AS-BUILT PLANS SANITARY SEWER IMPROVEMENTS

to serve PIKE ADD., PIKE 3RD & PIKE 4TH PHASE 3

CITY OF WICHITA, KANSAS

APPROVED AS NOTED
BY WICHITA PUBLIC WORKS ENGINEERING DIVISION
Engineering *Matt Sedky* 2/27/25
An approved copy of these plans signed by City staff are required on-site.

LINES 8 & 9

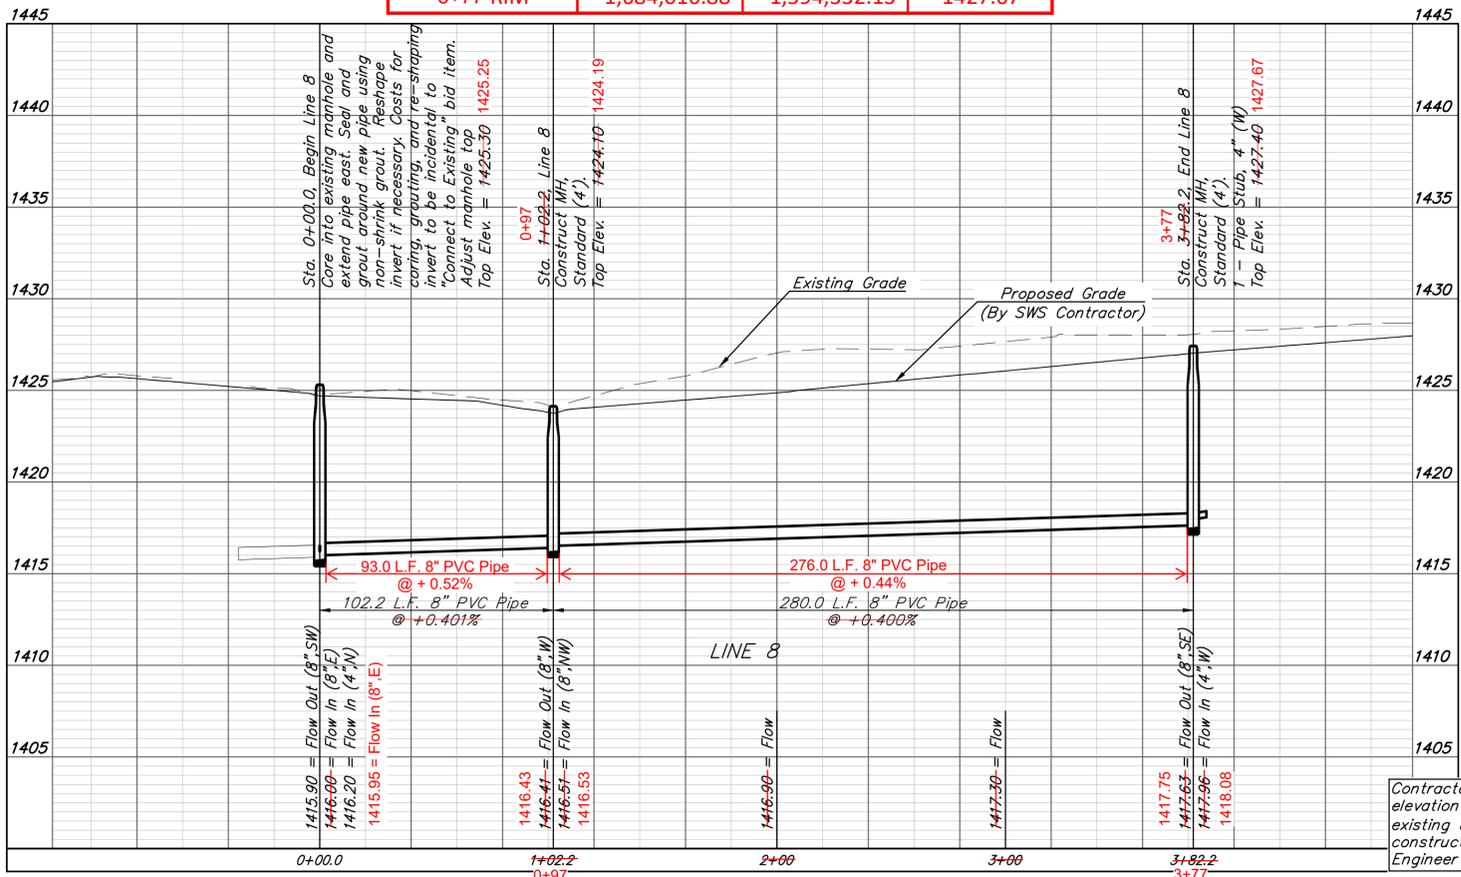
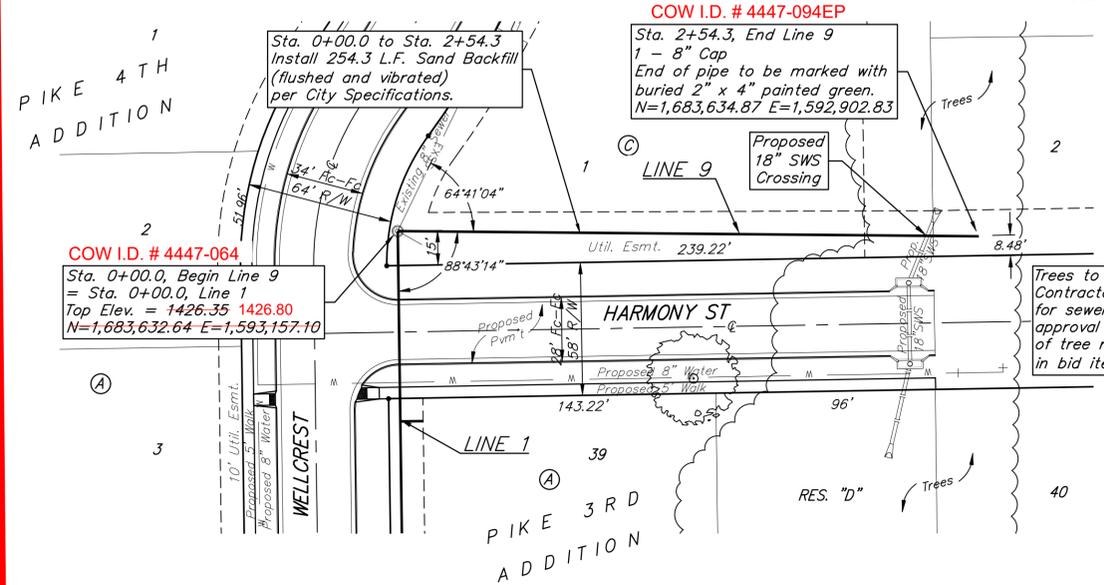
Sanitary Sewer Manhole Shifted Southwest to avoid Conflict with existing Irrigation System associated with Talia's Common Pond Area.
